**STAFF RECOMMENDATION**

**1000 Paris Avenue**

**September 18, 2019**

**Application:** New Construction—Addition

#### ATTACHMENT A: PHOTOGRAPH

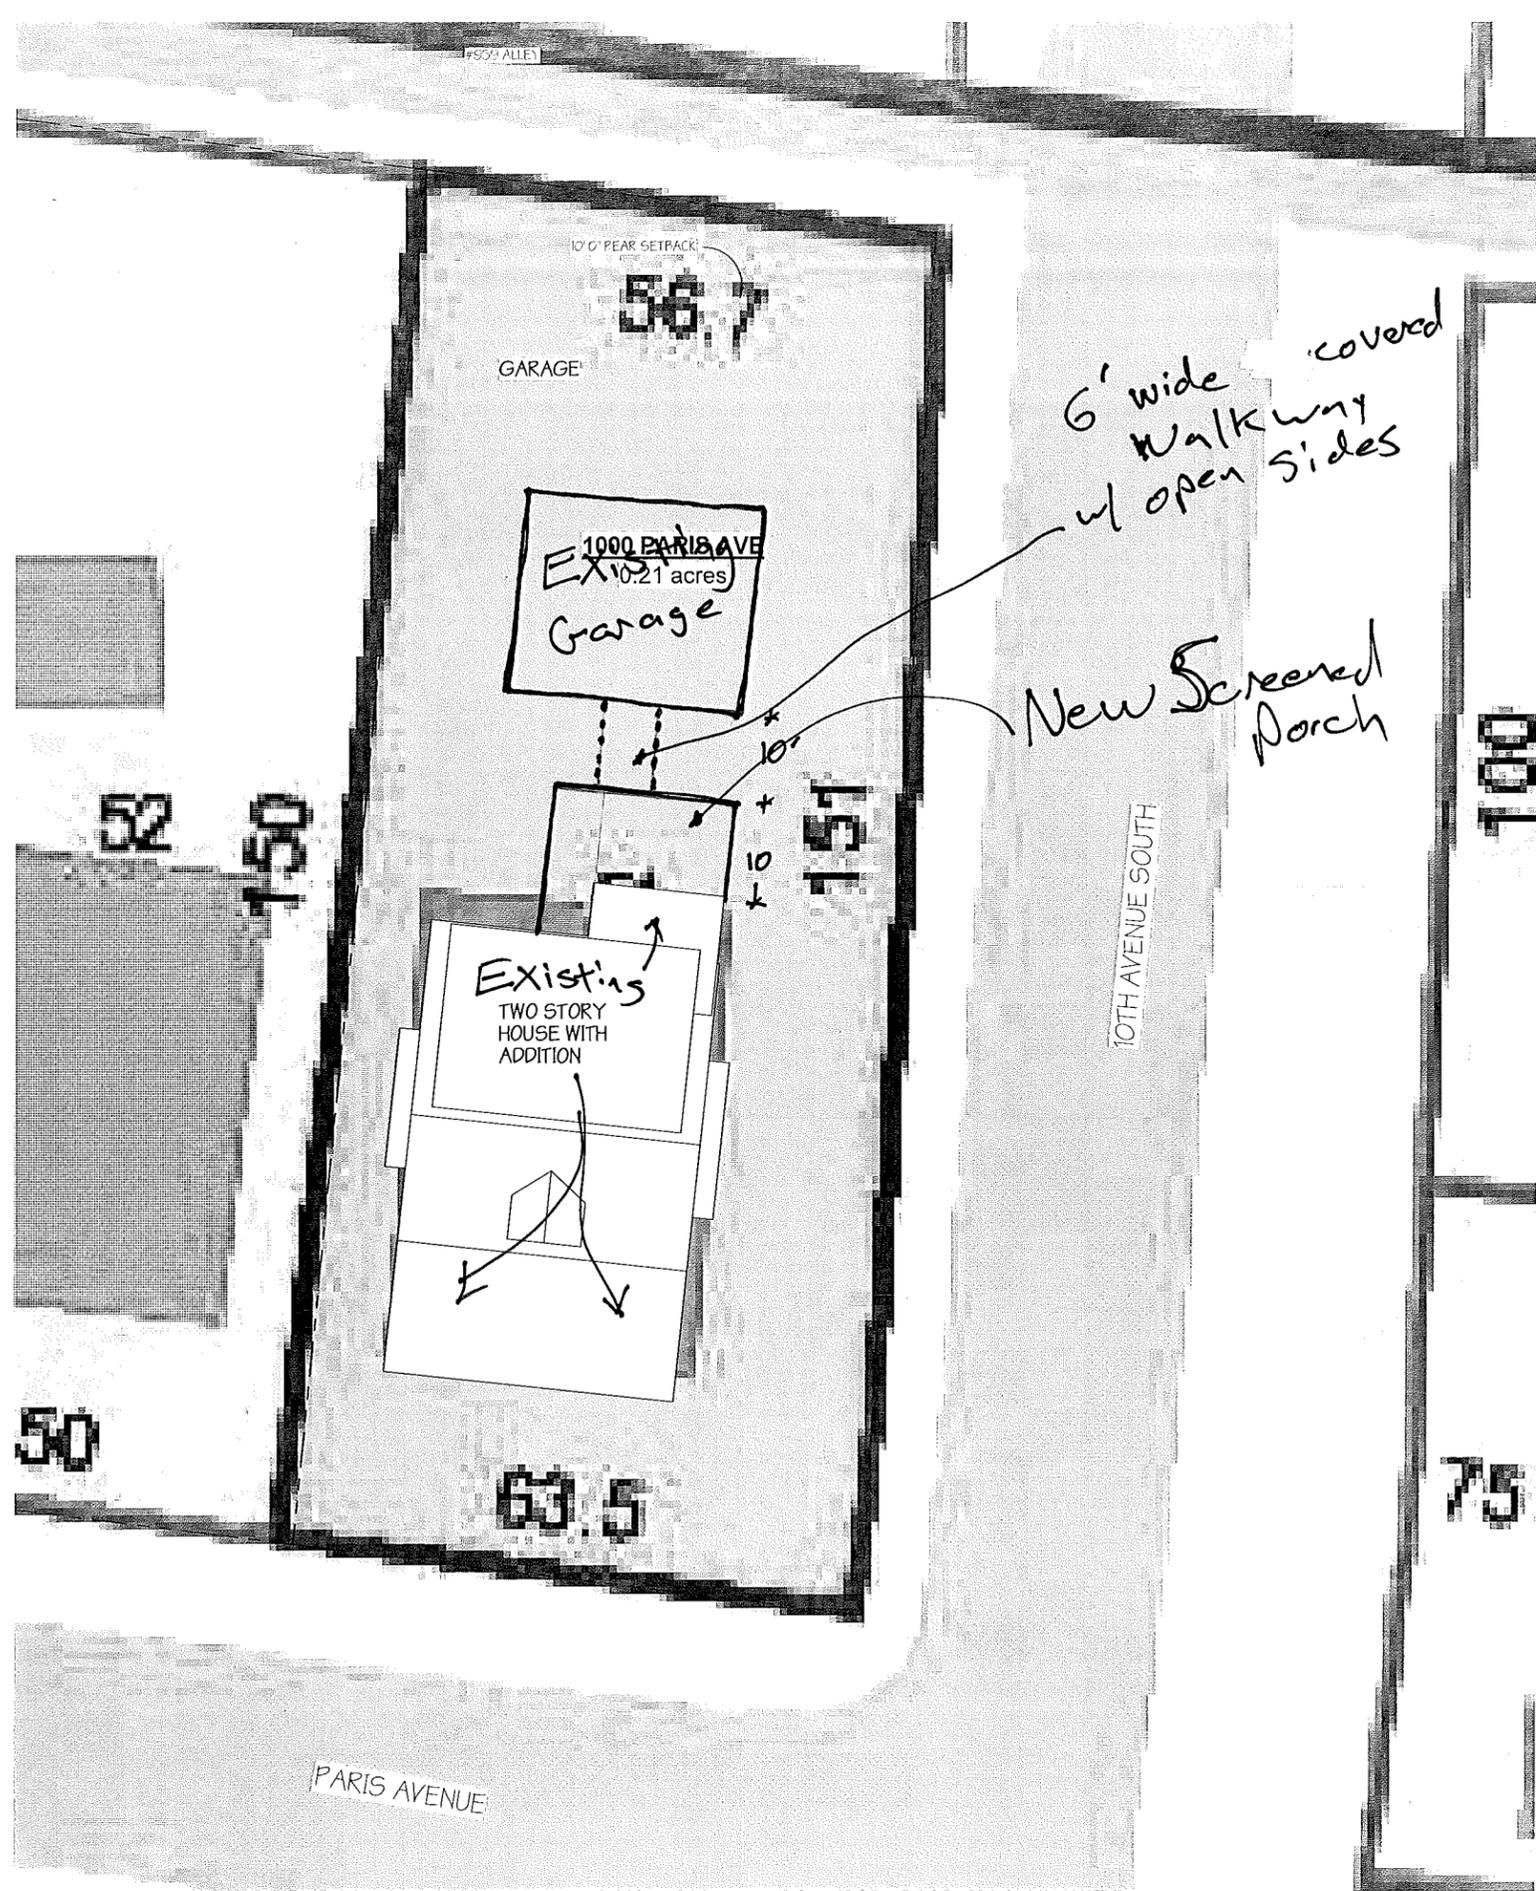
1009 Paris Avenue, right side. The new proposed porch will be span between the rear of the house and the center post of the pergola shown.
